CMS5 – BB CHANGES

CMS5 – DC CHANGES

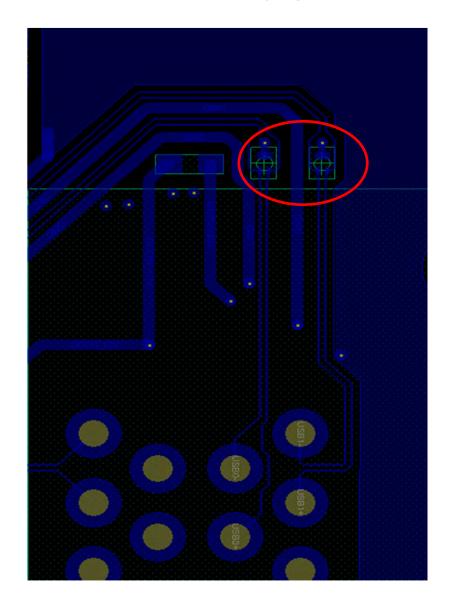
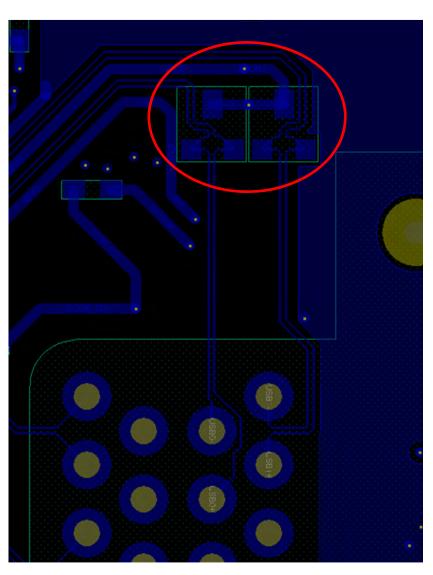
1. D1,D2,D7 &D8 (SOT-883) are Replaced with SOT 23-3 Package.

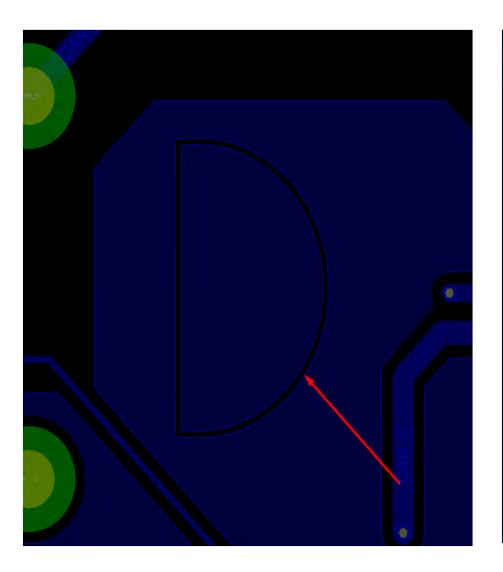
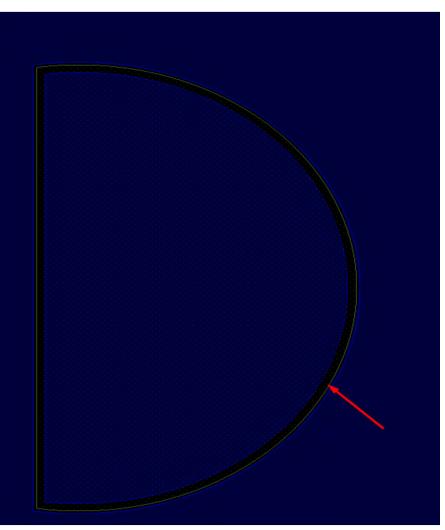
2. Solder Mask Opening for Copper Thieving Pads.

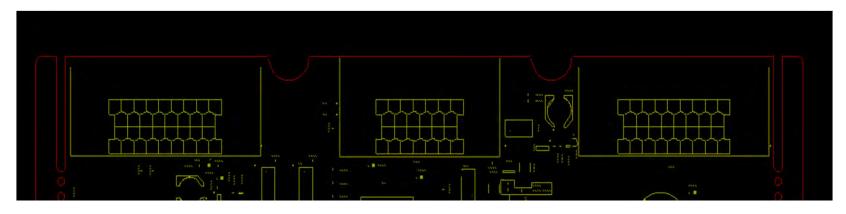
3. PCB Information Updated in Silkscreen and removed from Top and Bottom Copper.

4. Silkscreen for Connectors Updated in bottom side.

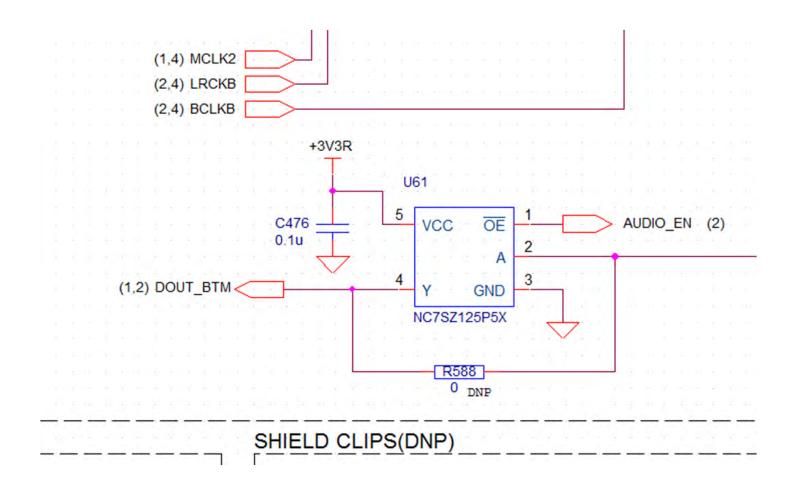
5. Buffer Circuit Added Near BT Module.

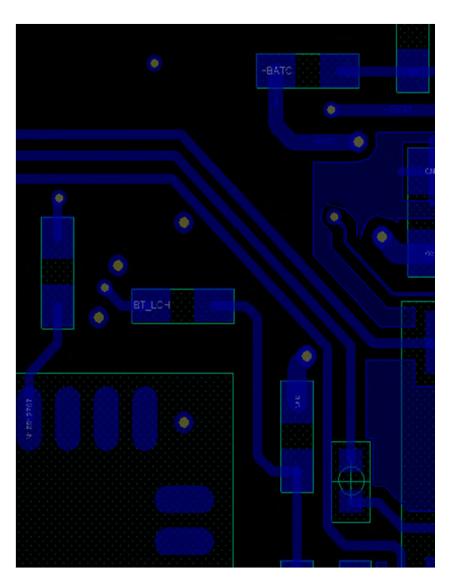
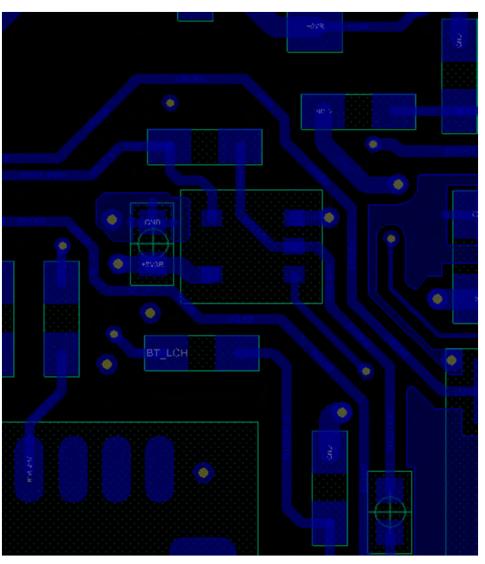
6. CN1,2&3 NPTH Clearance in Solder Side.

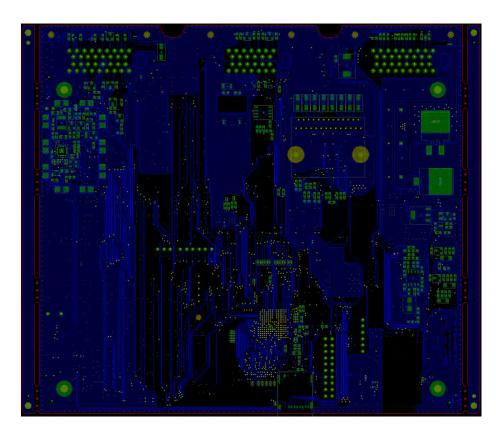
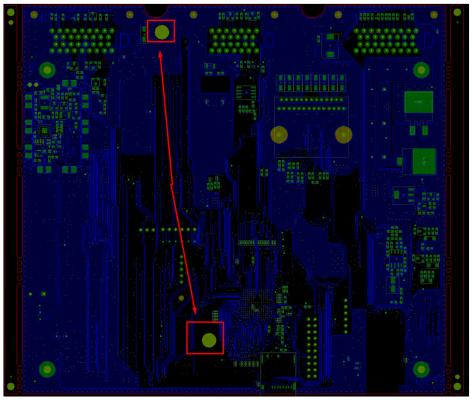
8. Silk Screen Added for Antenna Pins both top and bottom side(Top Side).

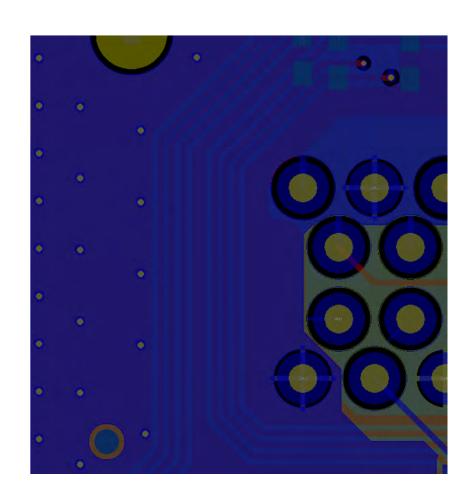
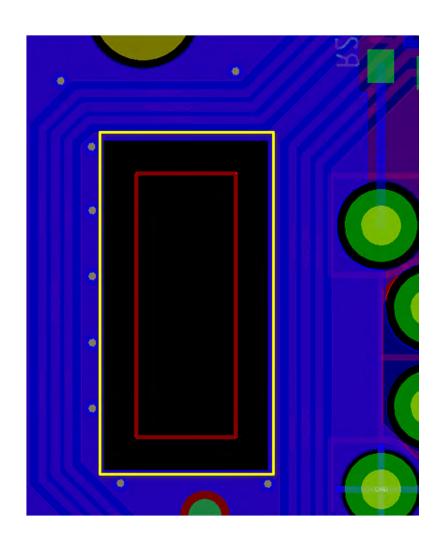
12. PCB slot is Introduced for Antenna Pig tail BB PP VERSION BB MP VERSION

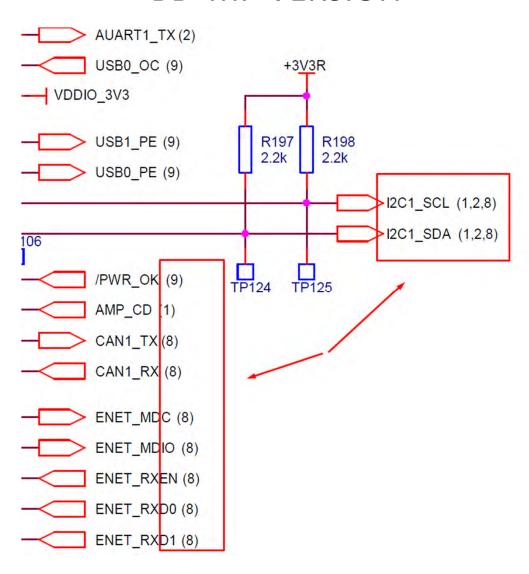
12. Inter sheet Reference for Off Page Connector Pins.

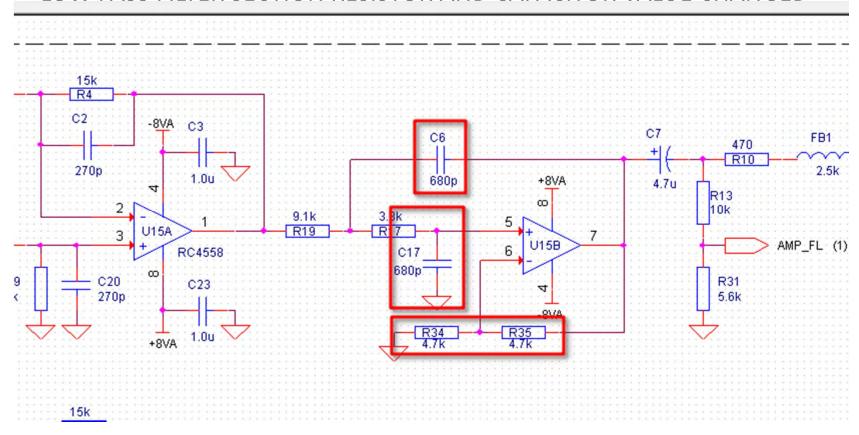
14. Schematic Changes (BOM Change).

LOW PASS FILTER SECTION RESISTOR AND CAPACITOR VALUE CHANGED

Resistors (R34,R35,R70, R71,R100, R101,R122, R123,R36, R37,R72, R73,R102, R103,R434, R435)changed from(5.6K&3K) to 4.7K Capacitors (C6, C17,C30,C41,C53, C65,C73, C79,C8, C21,C33, C43,C57, C66,C368, C410) changed from (820P&470P) to 680P

15. Schematic Changes. AM/FM/WB TUNER

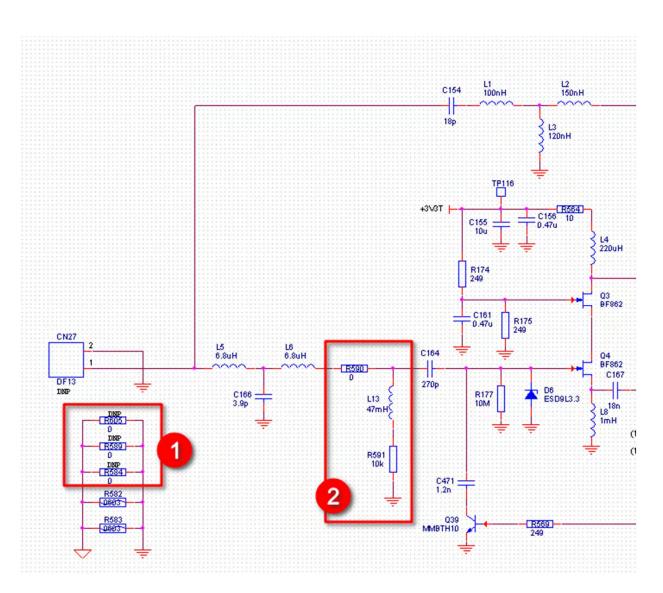
- 1. 0 Ohm resistor are newly added (R584,R589,R605).
- 2. Main strap circuit added newly.
- 3. SMD connector CN20 is removed from the design
- 4. R584 Resistor direct short removed.
- 5. R577 &R578 is removed from the design.
- 6. Sheild clip CN17 is removed from the design.

17. Schematic Changes. USB POWER SWITCHES

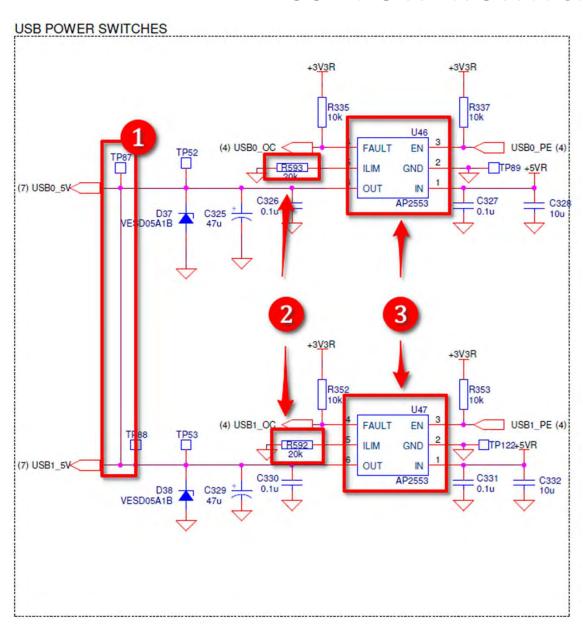
- Both USB Supplies Shorted.
- 2. R593 & R592 is newly added
- 3. U46 & U47 Part is changed from AP2191 To AP2553.

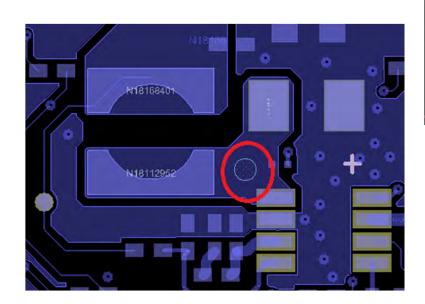
Rev No Updated (No copper Change)
